TI_2304 Compatibility of handle & drip tray for mobile oven rack and mobile plate rack for 20-1/1

iCombi Pro/iCombi Classic 20-1/1

04/07/2025

Affected components

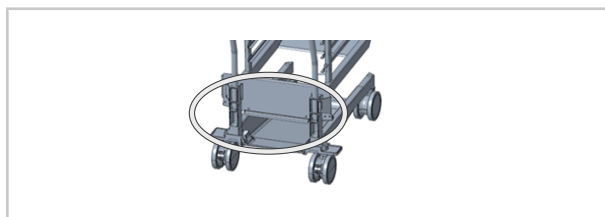
Due to structural modifications to the mobile oven rack and mobile plate rack of type 20-1/1 , the

- handle and
- removable drip tray

between cast iron variant (up to 10/2022) and stainless steel variant (from 10/2022) are not compatible.

Handle

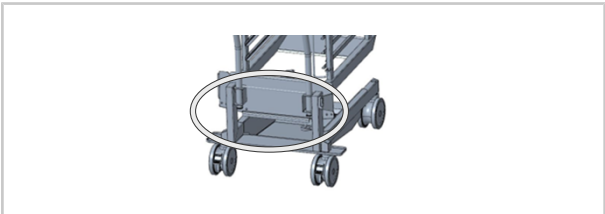
- Valid for cast iron mobile oven racks/mobile plate racks up to October 2022

- Valid for stainless steel mobile oven racks/mobile plate racks from October 2022

Component	Article number
Handle mobile oven rack/mobile plate rack model 20-1/1, compatibility version	60.21.473P

Drip pans

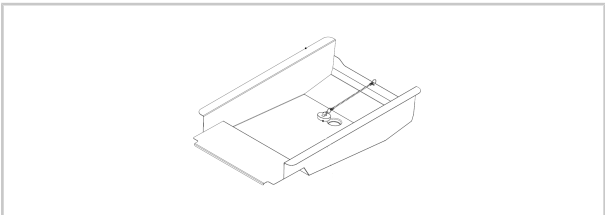
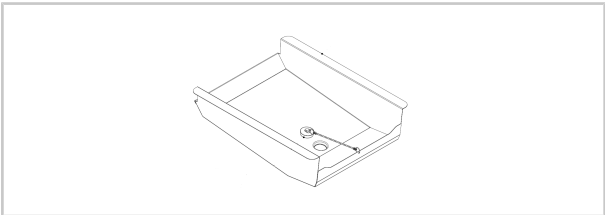
- Valid for cast iron mobile oven racks: 03/2020 to 10/2022

- Valid for stainless steel mobile oven racks: from 10/2022

Component	Article number
Drip tray for mobile oven rack (03/2020 to 10/2022)	60.21.479P
Drip tray for mobile oven rack (from 10/2022)	60.21.401P
